# CITY OF ALBUQUERQUE

**Re: Lot 36 Block 6 Unit 18 Volcano Cliffs, S.A.D. 228  
7900 Aguila Rd. NW  
Permanent C.O. – Accepted  
Engineers Stamp Date: 10/12/2020 by David Soule (D10D003I3)  
CO Certification Date: 8/23/2021 by Jackie McDowell**

## DRAINAGE AND TRANSPORTATION INFORMATION SHEET (REV 11/2018)

ENGINEER'S SEAL  10/12/20 DAVID SOULE P.E. #14522	LOT 3 BLOCK 9 UNIT 18 VC 7900 AGUILAR ST  GRADING AND DRAINAGE PLAN   1806 CENTRAL AVENUE SE SUITE 201 ALBUQUERQUE, NM 87106 (505) 872-0689	DRAWN BY DEM
		DATE 10-11-20 LOT 3 BLOCK 9 UNIT 18 VC.DWG SHEET # C1 JOB #

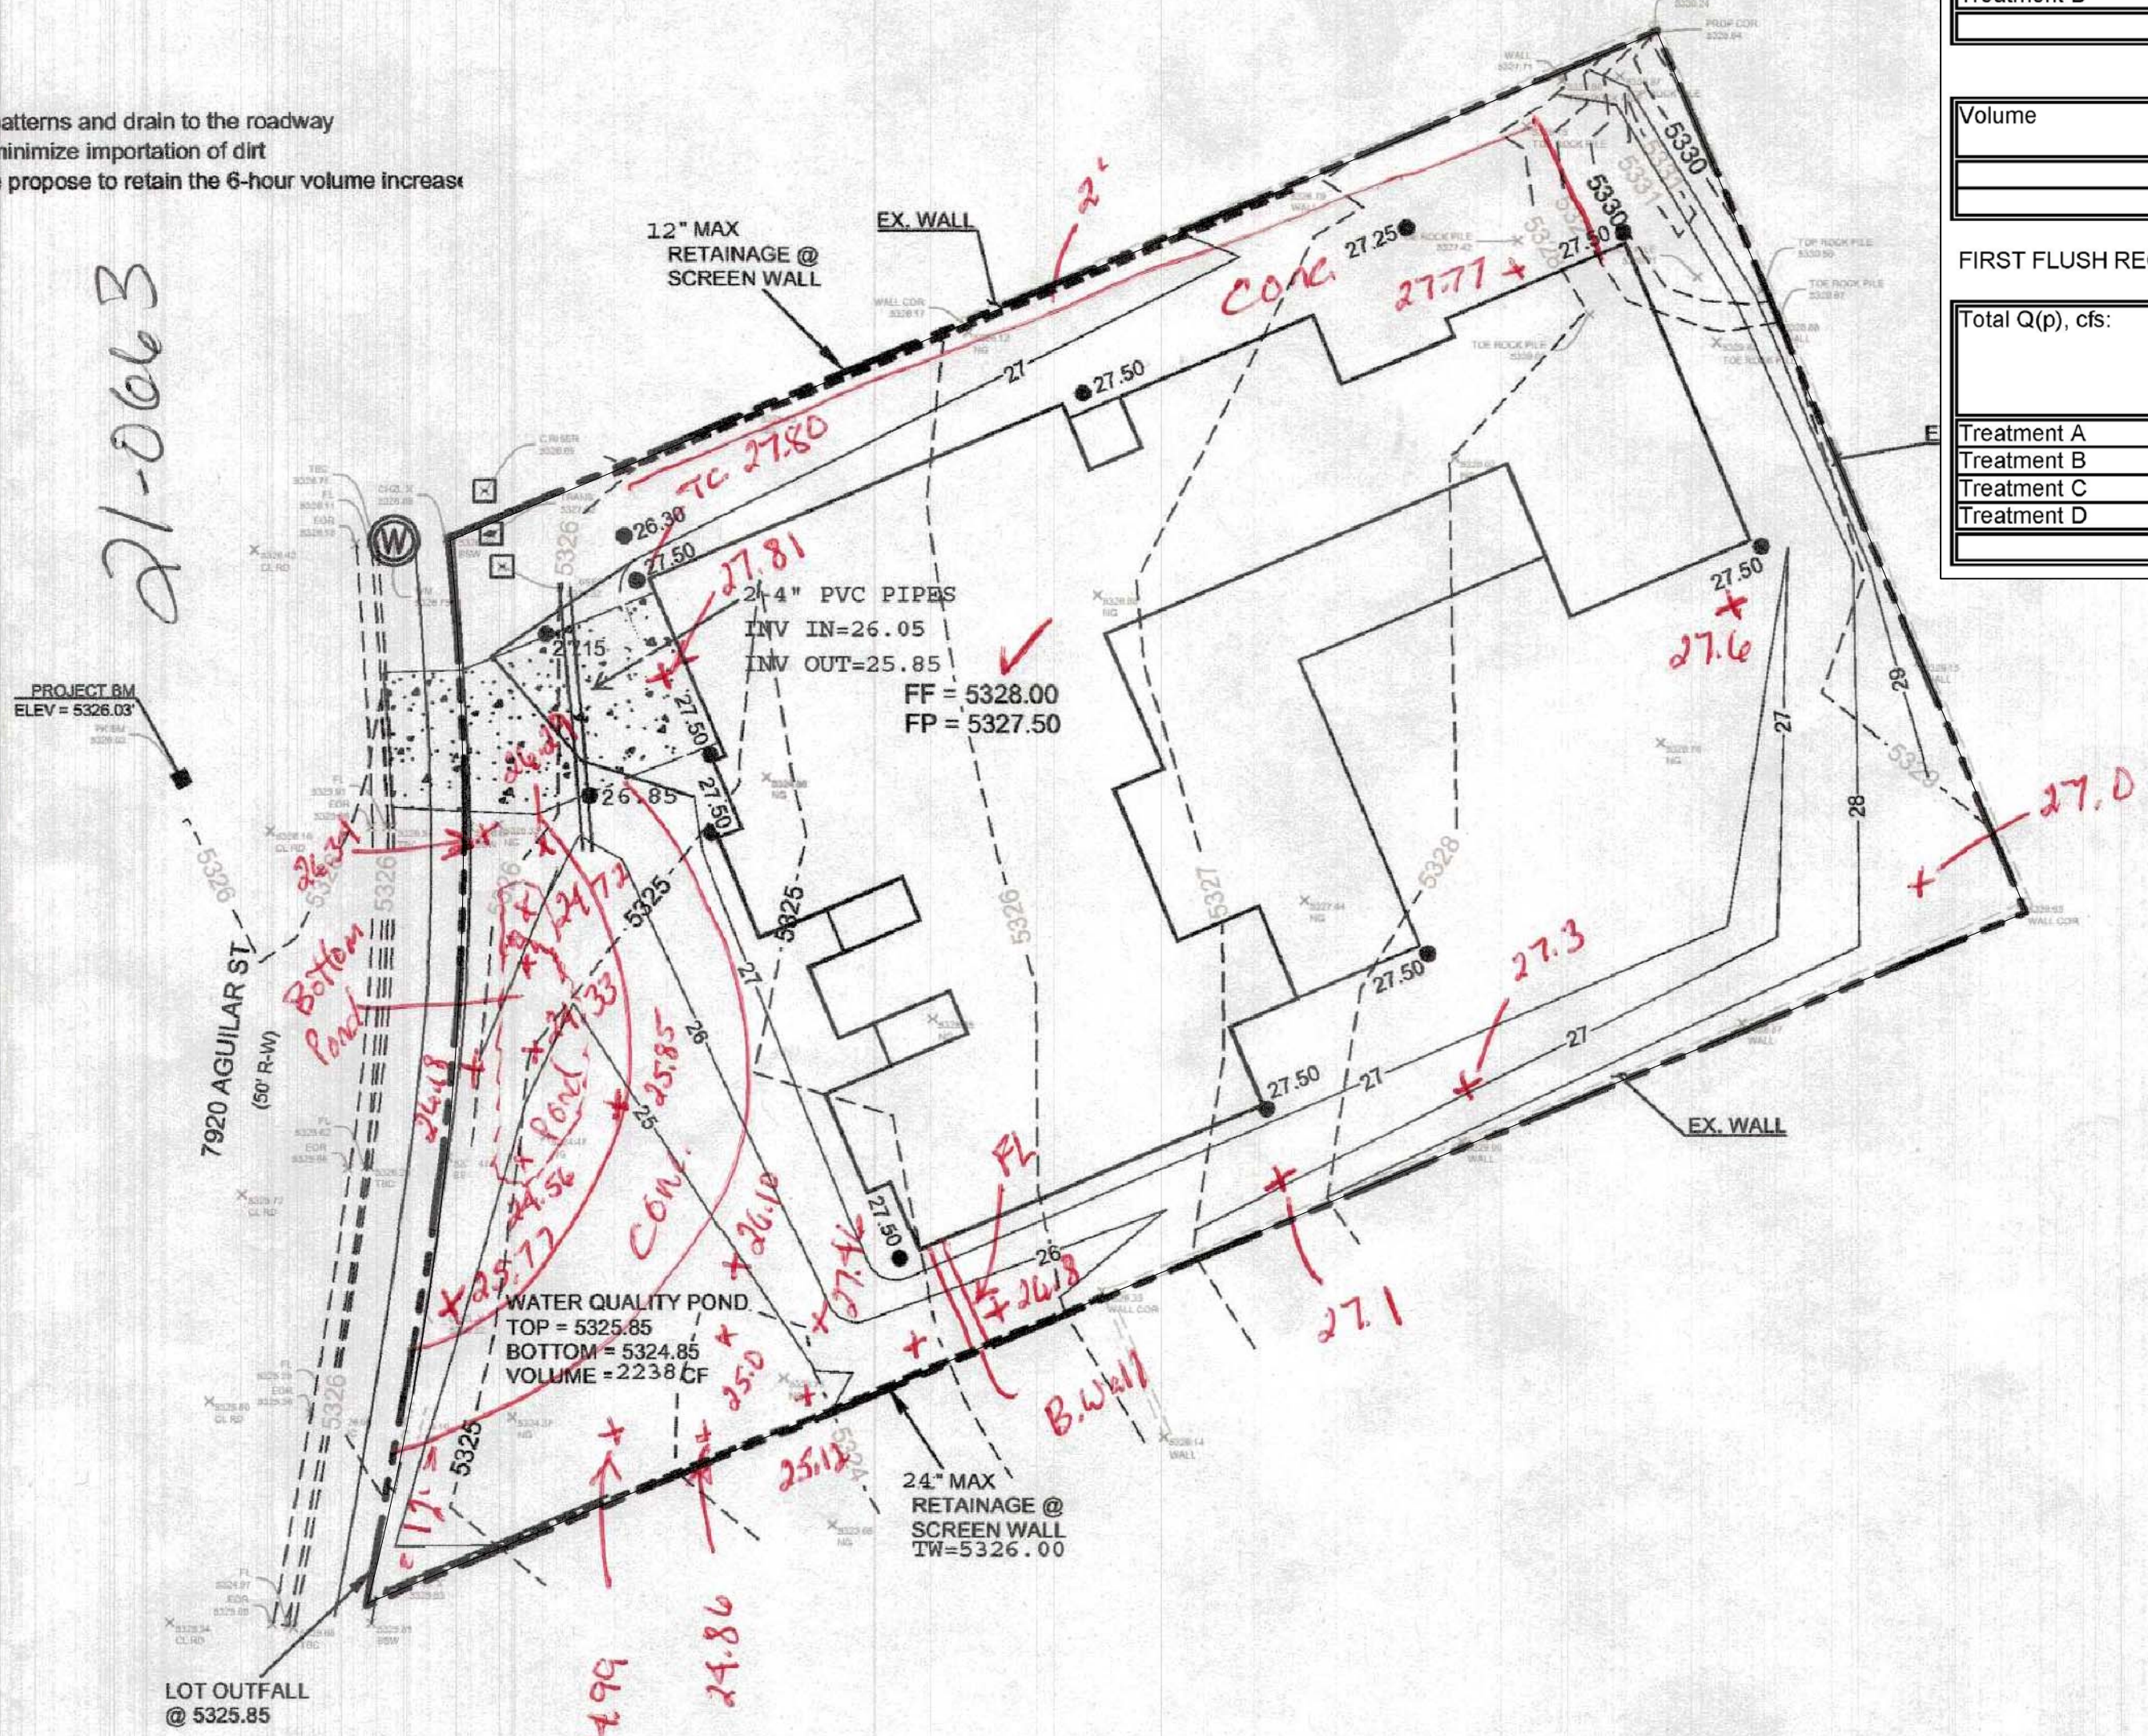
Adjustments to grading plan by Jackie McDowell of McDowell Engineering are listed in red ink. David Soule of Rio Grande Engineering gave permission to Jackie McDowell for the use of the original grading and drainage plan, for the completion of the CO process by hydrology. Email of approval by David Soule of Rio Grande Engineering is attached to electronic file

I, JACKIE S. MCDOWELL, NMPE # 10903, OF THE FIRM MCDOWELL ENGINEERING, INC., HEREBY CERTIFY THAT THIS PROJECT HAS BEEN GRADED AND WILL DRAIN IN SUBSTANTIAL COMPLIANCE WITH AND IN ACCORDANCE WITH THE DESIGN INTENT OF THE APPROVED PLAN DATED 10-12-20, PREPARED BY DAVID SOULE. I FURTHER CERTIFY THAT I HAVE PERSONALLY VISITED THE PROJECT SITE ON AUGUST 18, 2021 AND HAVE DETERMINED BY VISUAL INSPECTION THAT THE SURVEY DATA PROVIDED IS REPRESENTATIVE OF ACTUAL SITE CONDITIONS AND IS TRUE AND CORRECT TO THE BEST OF MY KNOWLEDGE AND BELIEF. THIS CERTIFICATION IS SUBMITTED IN SUPPORT FOR A REQUEST FOR CERTIFICATE OF OCCUPANCY.

Based on the Certification received 9/1/2021, the site is acceptable for release of Certificate of Occupancy by Hydrology.
